# UNITED STATES PATENT AND TRADEMARK OFFICE

APPLICATION NO.	FILING DATE	FIRST NAMED INVENTOR	ATTORNEY DOCKET NO.	CONFIRMATION NO.
10/791,101	03/02/2004	Shimshon Gottesfeld	107044-0043	2480
24267	7590	03/21/2008		
CESARI AND MCKENNA, LLP 88 BLACK FALCON AVENUE BOSTON, MA 02210				
EXAMINER				
CANTELMO, GREGG				
ART UNIT		PAPER NUMBER		
1795				
MAIL DATE		DELIVERY MODE		
03/21/2008		PAPER

### Office Action Summary

**FIG. 4**

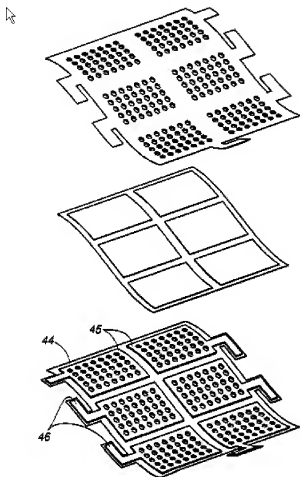
Pratt discloses a conformable fuel cell in Fig. 4, comprising: (A) a membrane electrolyte intimately interfacing with a catalyst layer along each of the membrane's major surfaces being a catalyzed membrane electrolyte, having an anode aspect and a cathode aspect, and which catalyzed membrane electrolyte is flexible (e.g., conformable to a desired shape); (B) diffusion layers sandwiching said catalyzed membrane

electrolyte, said diffusion layers being comprised of materials that are conformable; (C) flexible current collectors coupled with each of said anode aspect and said cathode aspect of said membrane electrolyte; (D) fuel delivery means coupled with said anode aspect of said membrane electrolyte that delivers fuel substantially uniformly to said anode aspect while said fuel cell maintains said desired shape (Figs. 2-5); (E) electrical coupling 45 disposed across said anode aspect and said cathode aspect and having means for connection to an application device being powered by said fuel cell (as applied to claim 1).

The housing shown in Figs. 3 and 4 is constructed and conformed to a desired contour, in this case a planar contour. This interpretation is a reasonable interpretation in light of the Applications own definition of the term conformable (see page 11, ll. 15-19 of the specification.

The current collectors 45 at each of said anode aspect and said cathode aspect apply "adequate compression" effectively over the active area of the membrane electrolyte of each cell (Fig. 4 as applied to claim 2)

The difference between claim 1 and Pratt is that Pratt does not expressly teach that the conformable fuel delivery means (conformable housing) maintains high compression along the active surfaces of the fuel cell (claim 1).
